APPLICATION FOR
CONSTRUCTION OF
PAVED
SIDEWALK/ DRIVEWAY

Application No. 11686

Driveway Review Form

Address: 23 Tarklin Hill Rd

Driveway Review

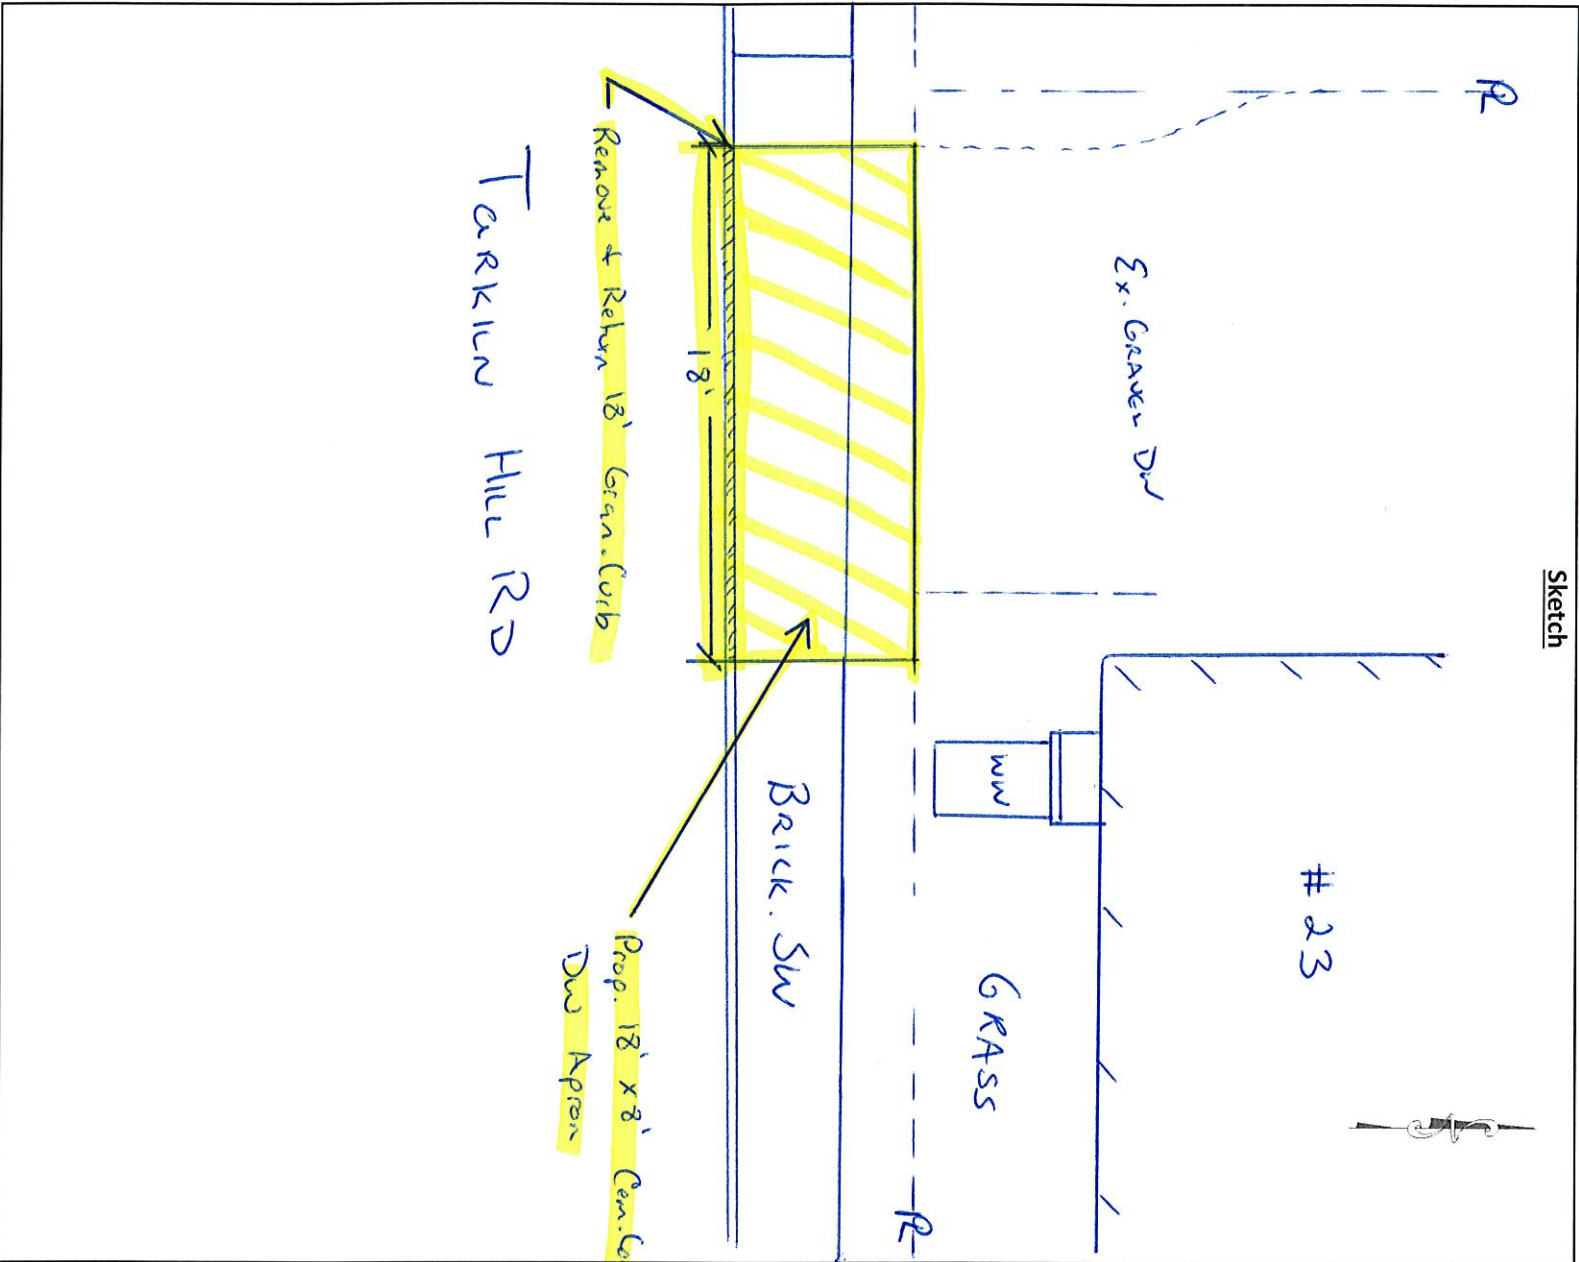
Additional Inspection Notes: 1. 18' Curb Cut. 2. Remove existing brick sidewalk area up to limits of existing cem.conc. SW west side limit and pre marked curb cut east side limit. 3. Install new 18' x 8' cem.conc.DW apron in accordance with most current DPI specs.
